# UNITED STATES PATENT AND TRADEMARK OFFICE

APPLICATION NO.	FILING DATE	FIRST NAMED INVENTOR	ATTORNEY DOCKET NO.	CONFIRMATION NO.
10/723,126	11/25/2003	Donald R. Gilbreath	C02-085A	9442
26683	7590	07/26/2004	EXAMINER	
THE GATES CORPORATION IP LAW DEPT. 10-A3 1551 WEWATTA STREET DENVER, CO 80202			DUNWOODY, AARON M	
		ART UNIT	PAPER NUMBER	
		3679

<b>Office Action Summary</b>	Application No.	Applicant(s)
	10/723,126	GILBREATH, DONALD R.
	Examiner Aaron M Dunwoody	Art Unit 3679

## **DETAILED ACTION**

**F I G . 4**

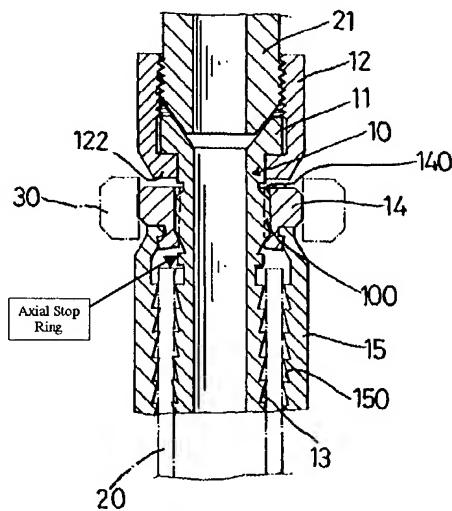
In regards to claim 1, Huang discloses an improved hydraulic fitting having a stem (10) including a hose insert portion, and a collar support portion, having a mating connection portion, and a collar having, a torque communication portion, a female support portion, and an inner periphery extending through the ferrule support portion and the torque communication portion, the improvement comprising:

the collar support portion including knurling (100) and an axial stop ring (see Figure 4 below),

the torque communication portion being staked such that the inner periphery extending through the torque communication portion communicates with the knurling in a relatively non-rotational manner, and

the ferrule support portion being staked such that the inner periphery extending through the ferrule support portion communicates with the axial stop ring in an axial movement limiting manner.
